Department of
Conservation and
Development

Contra Costa County

**Re: Comments on the Department of Water Resources' 2015 California WaterFix Section
404/10 Application
Public Notice SPK-2008-00861**

Attachment B**Contra Costa County Comments on WaterFix RDEIR/SDEIS****General Comment on the Inadequacy of All BDCP Alternatives**

Figure 3-5 illustrates the impact of the proposed project on salinity at CCWD's Old River Intake for the entire 82-year study period.

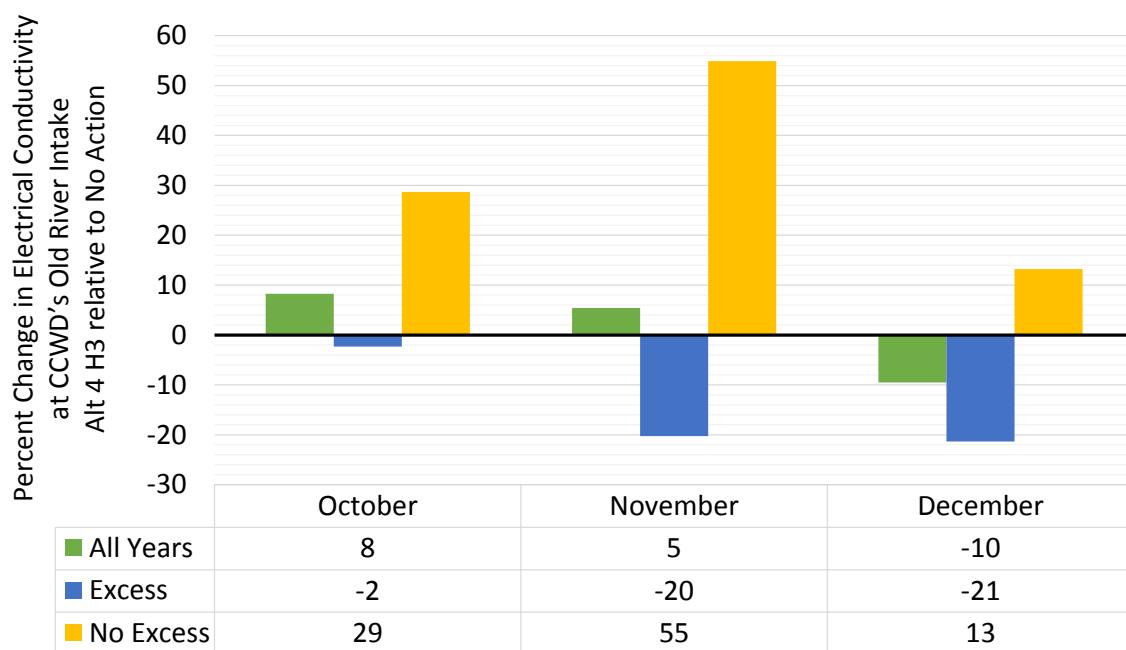
The unrealistic excess Delta outflow in October freshens the modeled interior Delta salinity for many months. This is illustrated in Figure 3-5, which shows that excess Delta outflow in October freshens the water at CCWD's Old River Intake in October and that the freshening effect is maintained through December (blue bars in Figure 3-5). In contrast, during years without excess Delta outflow in October, Alternative 4/4A H3 increases the salinity at CCWD's Old River Intake in October, November, and December (orange bars in Figure 3-5). Further, averaging salinity over all years (green bars in Figure 3-5) underestimates the impacts that would occur.

This discussion serves to show that the unrealistic assumption of excess Delta outflow results in a significant underestimation of salinity impacts as a result of the proposed project. Conversely, implementing and modeling an operations plan that corrects this unrealistic excess Delta outflow assumption would reveal greater salinity impacts due to the project.

Figure 5-1. Change in Salinity due to the ELT Tidal Marsh

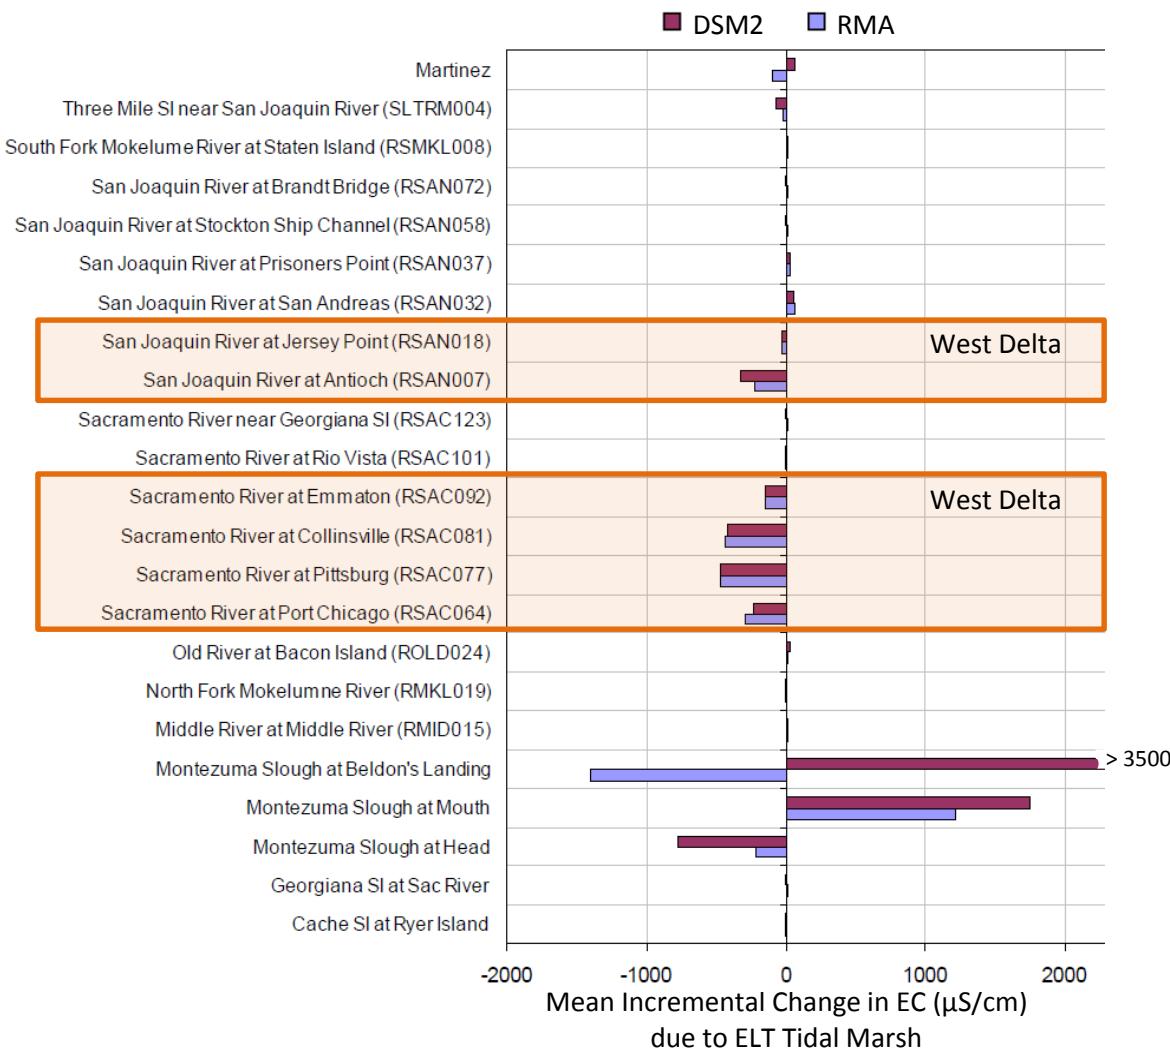
However, there is no evidence presented in the RDEIR/SDEIS to support this conclusion. To the contrary, the analysis in the 2013 BDCP Draft EIR/EIS clearly indicates that the particular configuration of tidal marsh included in the modeling *underestimates* salinity impacts, since the modeled restoration reduces salinity in the western Delta. For example, Figure 5-1 below is a reproduction of a figure from the 2013 BDCP Draft EIR/EIS that shows the incremental change in electrical conductivity (EC) due to the ELT tidal marsh configuration (25,000 acres) that was assumed in the models; the locations in the west Delta are boxed for easy identification. At every location analyzed in the west Delta, the mean incremental change in EC due to the ELT tidal marsh is negative, indicating that the incorporation of the ELT tidal marsh reduces salinity at these locations for both models that are used to simulate salinity in the Delta (i.e., DSM2 and RMA). Multiple figures in the 2013 BDCP Draft EIR/EIS illustrate that the ELT tidal marsh configuration reduces salinity in the west Delta. *See, e.g., 2013 BDCP Draft EIR/EIS, Appendix 5A, Section D, Attachment 2, Figures 6-26, 6-29, 6-32, 6-35, and 6-41 and Attachment 4, Figures 1-69 to 1-72.*

In short, the tidal marsh assumed for the ELT reduces salinity in the west Delta. Thus, including the ELT tidal marsh in the modeling to simulate the project alternatives, when in fact the tidal marsh will not be constructed as part of the alternatives, *underestimates* the impacts to salinity in the west Delta that would be caused by the alternatives.

Figure 5-3. HORB affects water quality in the south and central Delta

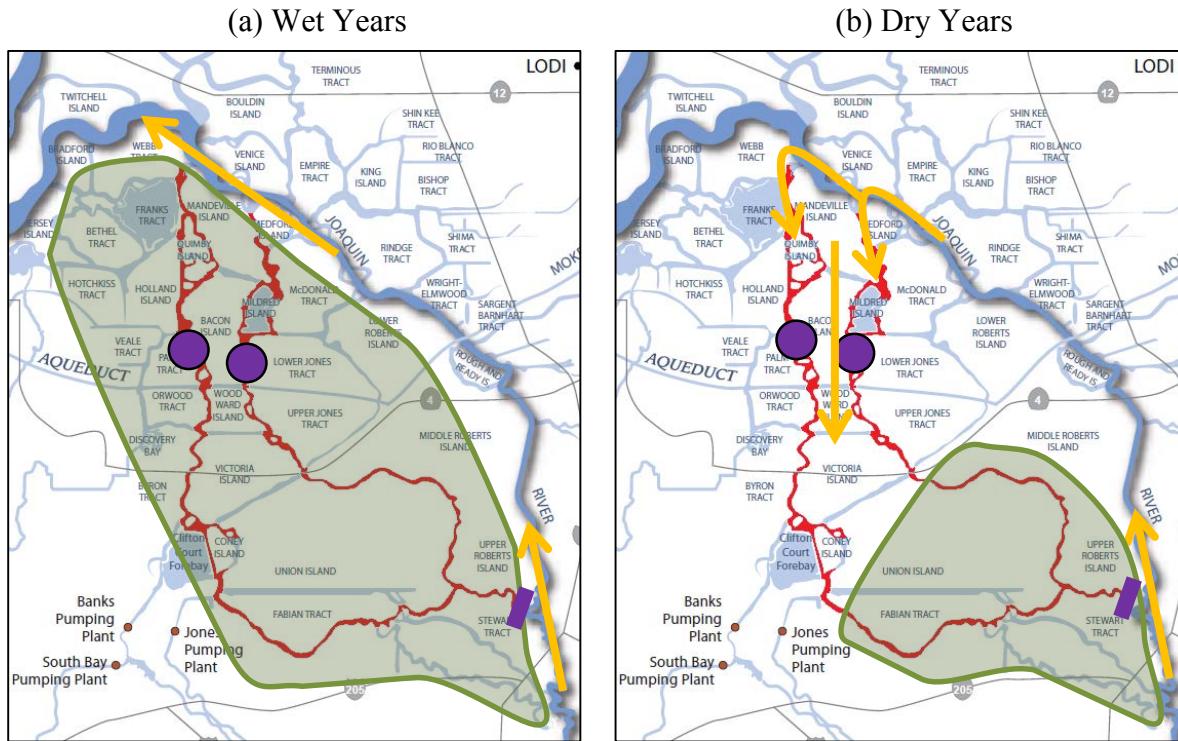
Closure of the HORB impacts the water quality in the south and central Delta; Figure 5-3 shows the geographical extent of the impacts in wet and dry years.

During dry years, the project as described in the RDEIR/SDEIS allows OMR to be negative while the HORB is closed. With no flow entering Old River from the San Joaquin River at the HORB, and with the export pumps operating, the San Joaquin River would flow north past the HORB, then turn south entering Old and Middle Rivers from the north and creating negative OMR (Figure 5-3(b)). The central Delta would receive this water heading from the north, and thus would receive a greater proportion of San Joaquin River water as compared to baseline conditions. This is an important consideration for water quality in the central Delta, since during dry years, San Joaquin River flows are generally low and the water quality is poor. Further, with the HORB closed, stagnant conditions would be created in the south Delta.

For both wet and dry years, impacts would be greater than what is modeled. In the stagnant regions, flow in the channels would oscillate with the tides, but without net flow, the residence time would be very long. (Residence time is estimated by the volume of water in a region divided by the net flow through the region, so as the net flow approaches zero, the residence time approaches infinity.) Long residence times provide optimal conditions for harmful algal blooms as discussed in Section 2.2.1.2 of CCWD’s July 25, 2014 comment letter on the 2013 BDCP Draft EIR/EIS.

Figure 5-4. HORB affects water quality in the south and central Delta, sensitivity study results

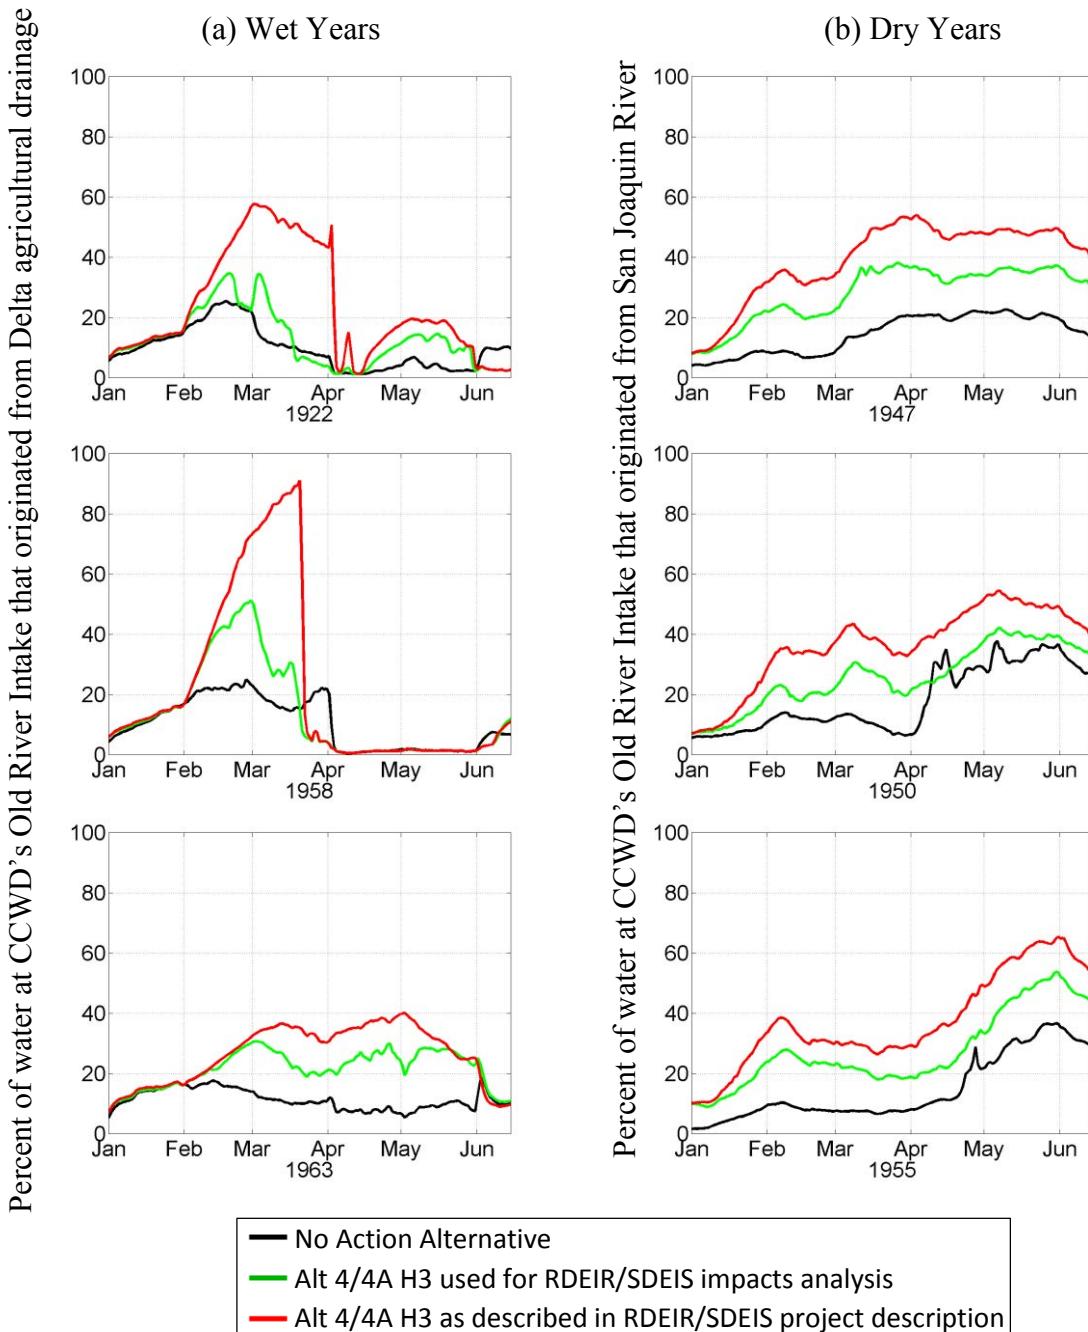
CCWD conducted a sensitivity study to evaluate the degree to which the analysis in the RDEIR/SDEIS underestimates the impacts of the new alternatives. Unlike the modeling used for the impact analysis in the RDEIR/SDEIS, CCWD's sensitivity study assumes that the HORB is closed when the project description indicates it should be closed. The CCWD study also reduced south Delta exports if necessary to attempt to meet the OMR requirement. Note that because no parameters are indicated in the project description to open the HORB for water quality or water stage concerns, this was not simulated in the CCWD study. Figure 5-4 illustrates the results for three wet years (Figure 5-4(a)) and three dry years (Figure 5-4(b)). In all six years, the negative water quality effects of the proposed project are greater than what is disclosed and evaluated in the RDEIR/SDEIS.

Results of CCWD's sensitivity study (red lines) indicate that the modeling used for the RDEIR/SDEIS impacts analysis (green lines) underestimate the project's adverse impacts on water quality relative to the baseline (black lines). In relatively wet years (a), an increase in percent of water from Delta agricultural drainage would increase salinity, nutrients, algal biomass, and pesticides at CCWD's intakes. In relatively dry years (b), an increase in the percent of water from the San Joaquin River would increase salinity, nutrients, and pesticides at CCWD's intakes.
